NOTICE OF APPROVAL

Planning Case #: Landscape Plan Check/Inspection 23263

Project Description: This approval of Landscape Design application LD 23-263 (Davis) authorizes revisions to the approved landscape plan (DS 17-398, Quan) and minor site modifications to a single-family residence currently under construction located at the northwest corner of Carpenter Street and 6th Avenue in the Single-Family Residential (R-1) District as depicted in the plans prepared by Bliss Landscape Architecture stamped approved and on file in the Community Planning & Building Department unless modified by the conditions of approval.

THE DAVIS RESIDENCE

Drawing Title
MATERIALS
SPECIFICATIONS

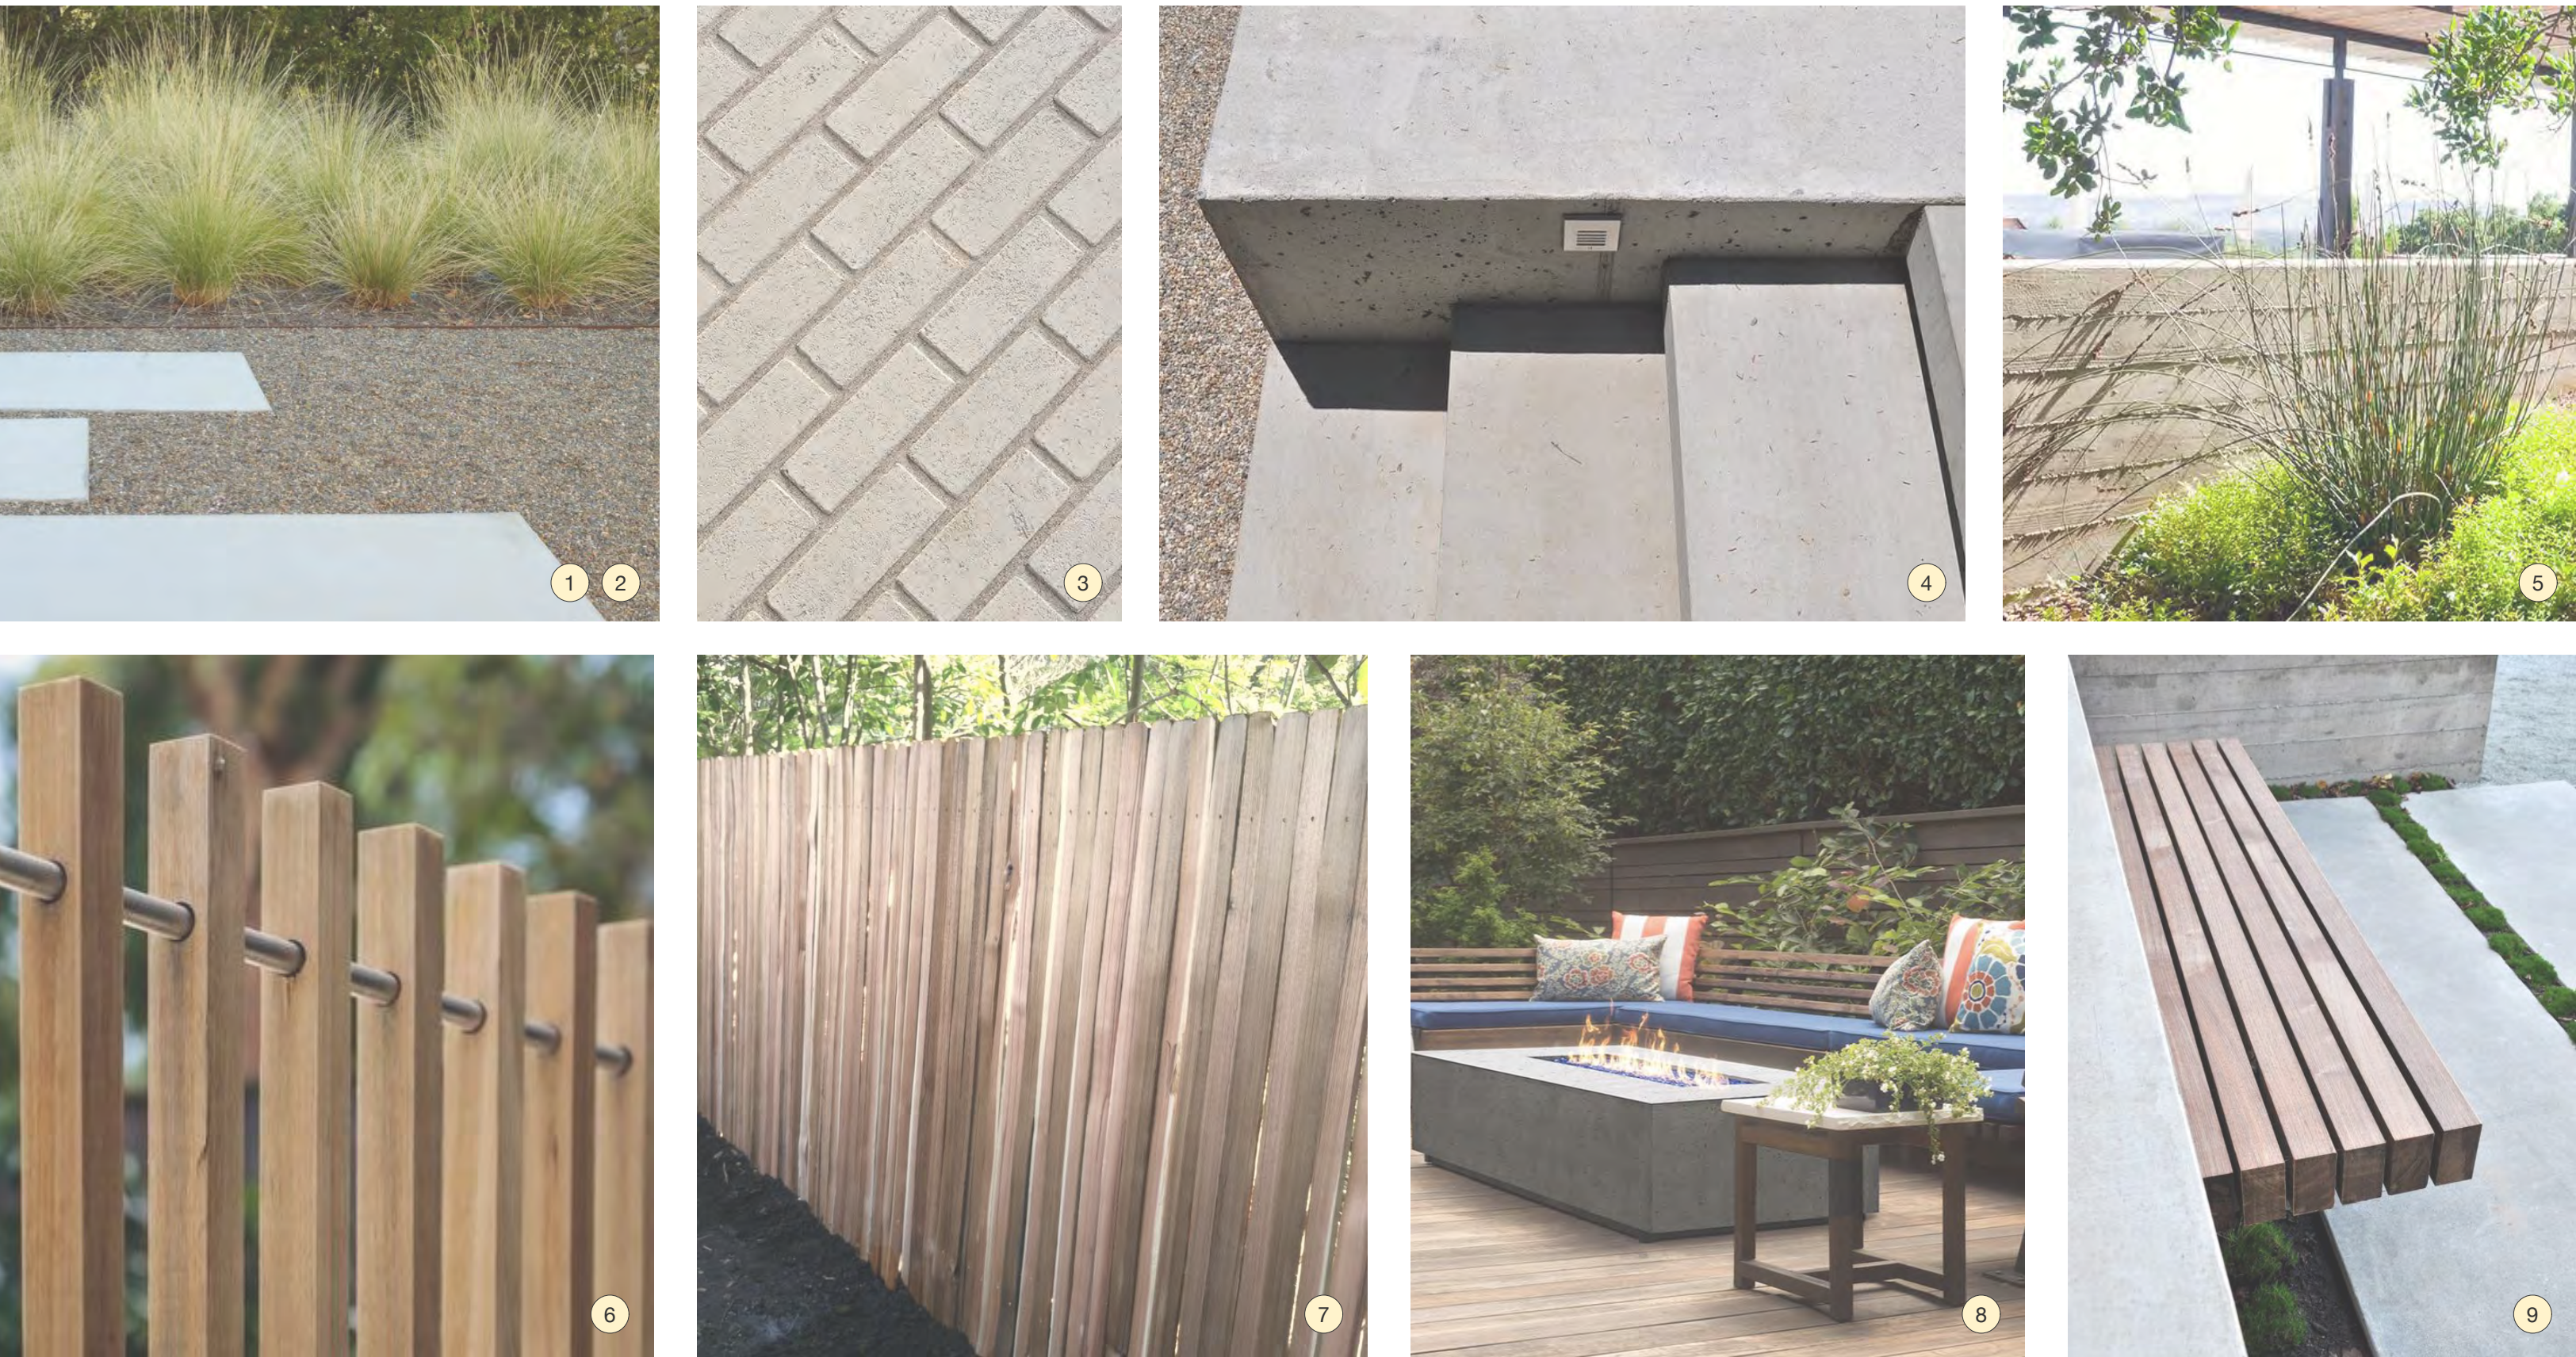
Specs have been updated

L1.2

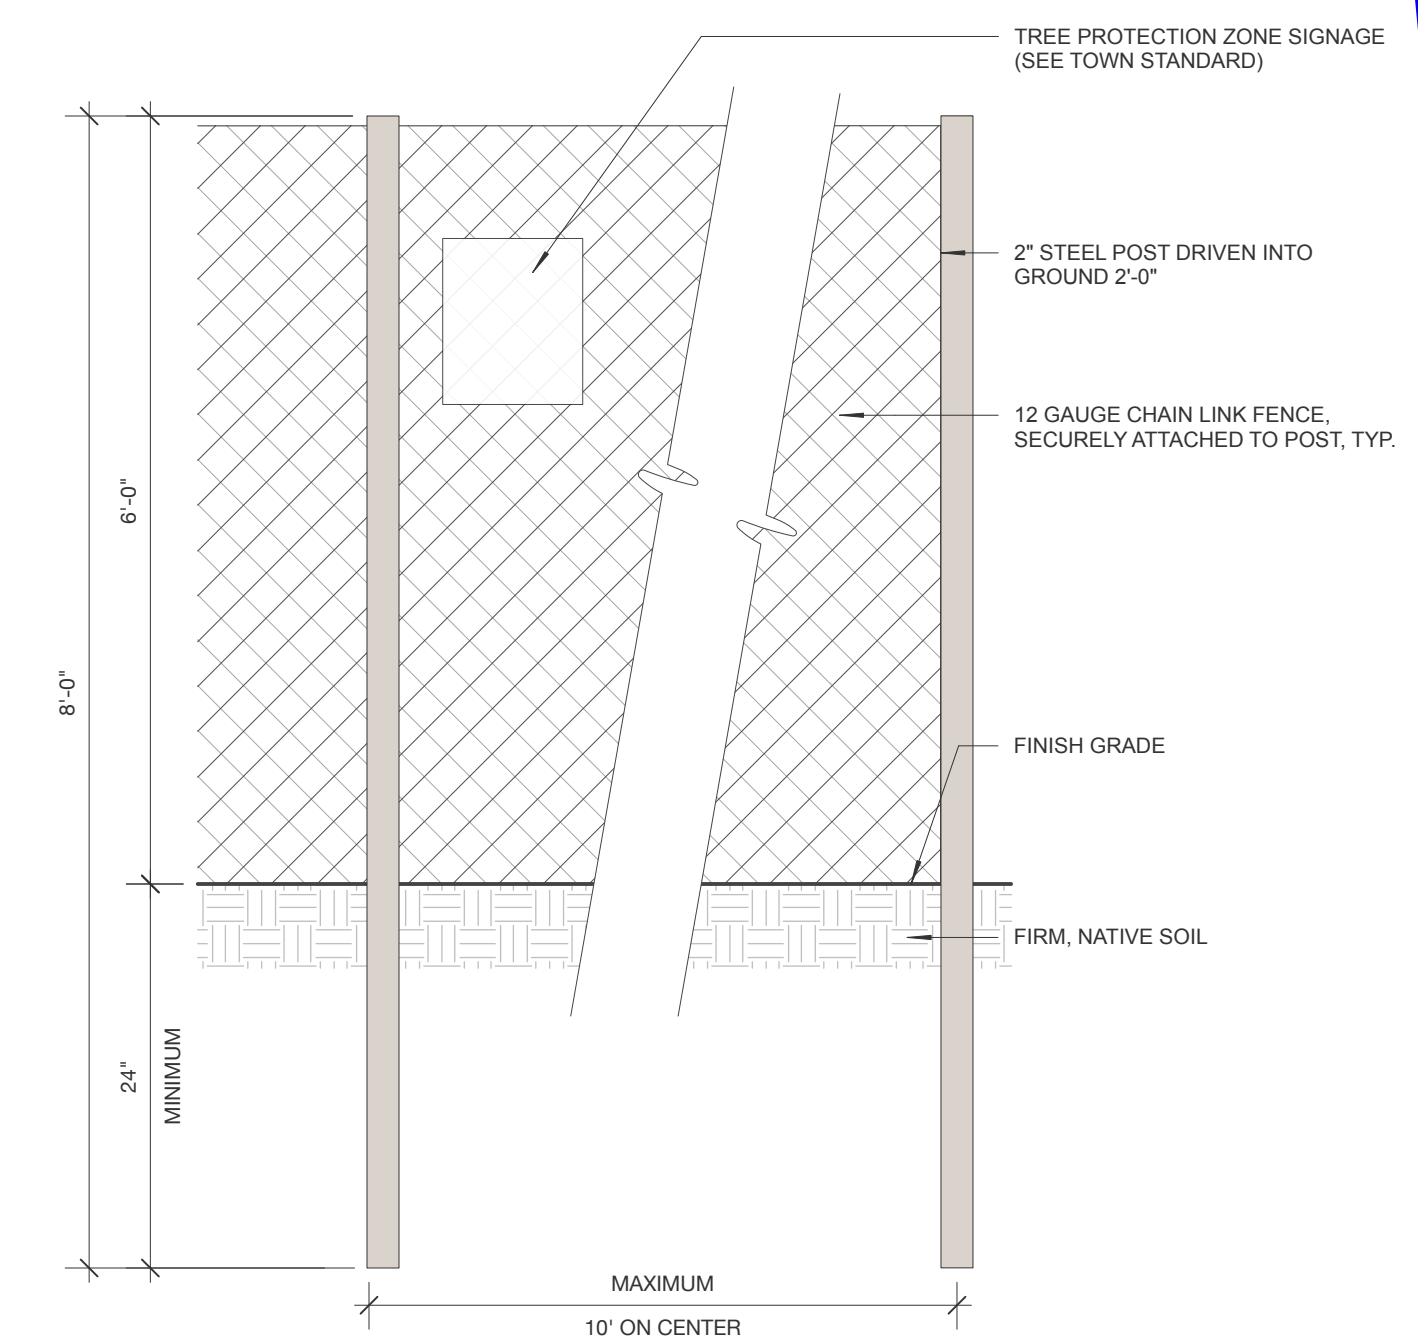
The layout plan is updated per the new changes
